PEAK GYMNASTICS

EL PASO COUNTY, STATE OF COLORADO
GRADING & EROSION CONTROL PLAN

GRADING & EROSION CONTROL PLAN
PEAK GYMNASTICS
JOB NO. 44-032
DATE PREPARED: SEPTEMBER 30, 2018
DATE REVISED:

EL PASO COUNTY FILE NO. PPR 18-035

SHEET 2 OF 3

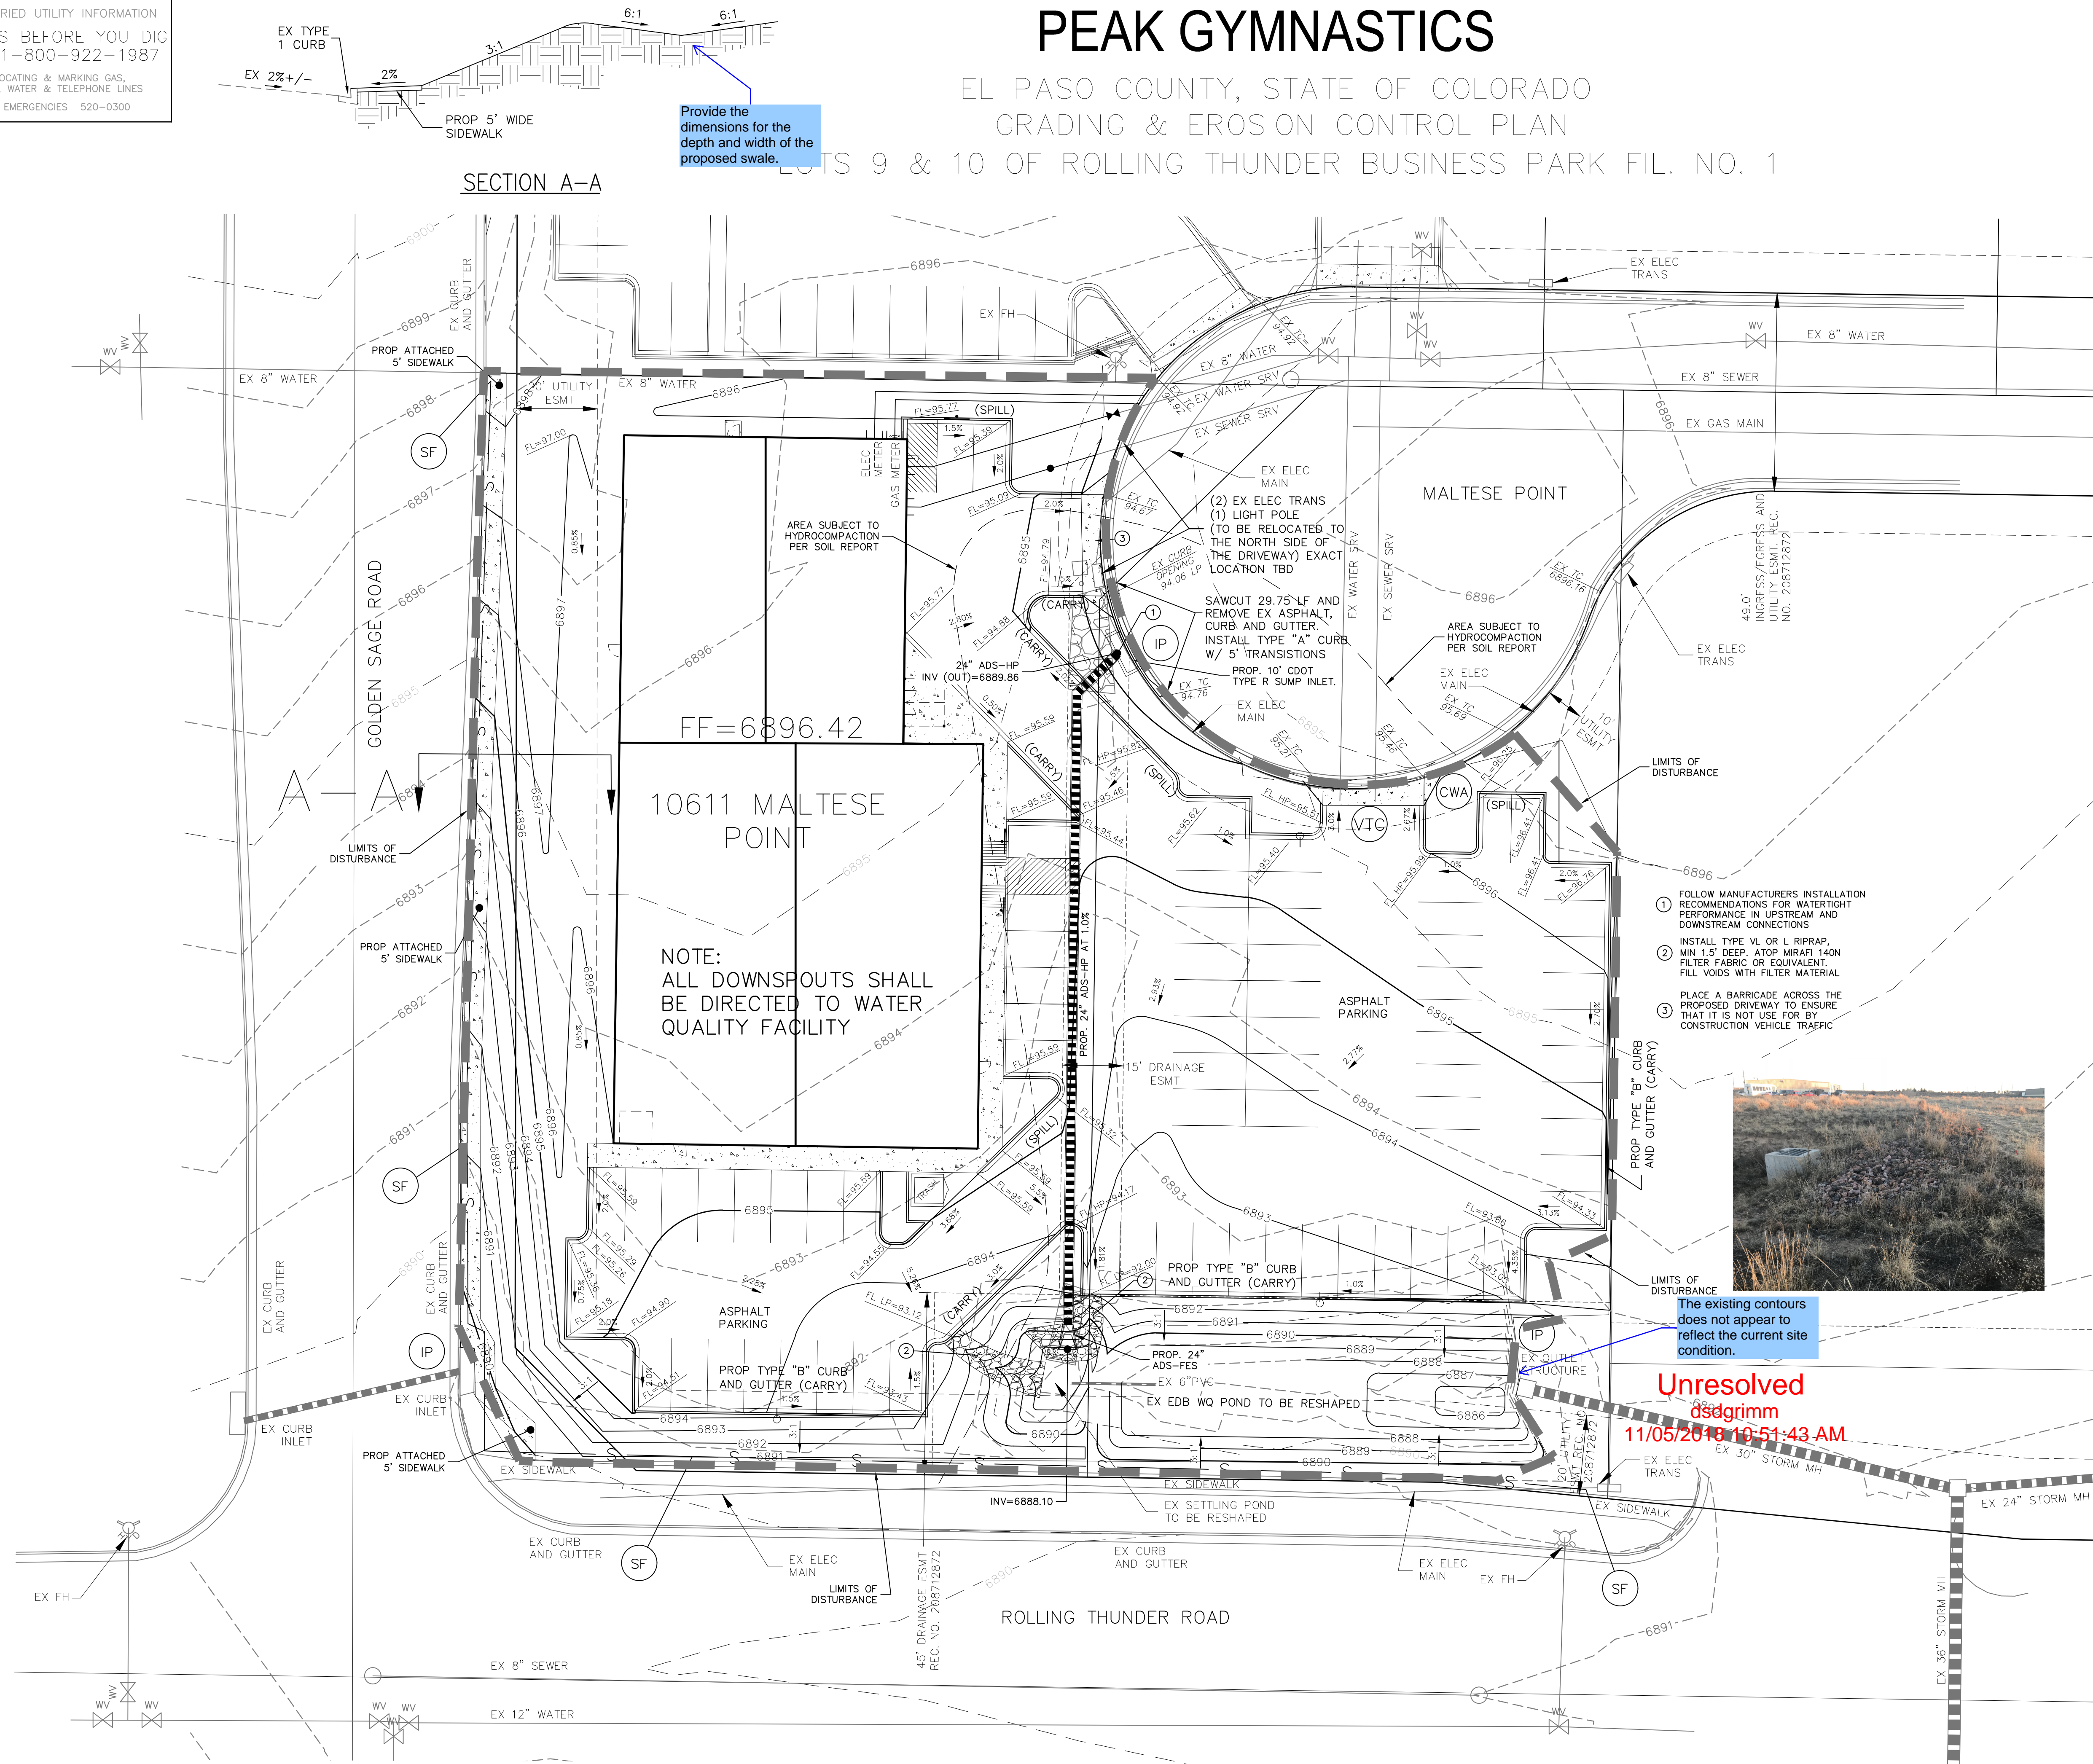
Provide the dimensions for the depth and width of the proposed swale.

The existing contours
does not appear to
reflect the current site
condition.
